Access Compliance Report Public Rights-of-Way (Curb Ramps)

Main Street: VINE_ST Cross Street: EARLHAM_ST Location: SE

ADA ID: RPAT210927105253 Ramp Type: Type 4 - Parallel Initial Pass/Fail: Fail Overall Compliance: No Severity Score: 16

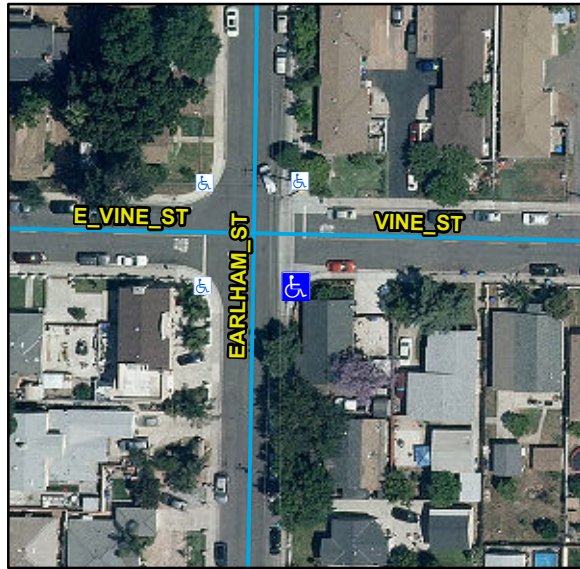
R304.3.2, STD 1115

Remove & Replace Curb Ramp With Two New Directional Ramps or Equivalent.
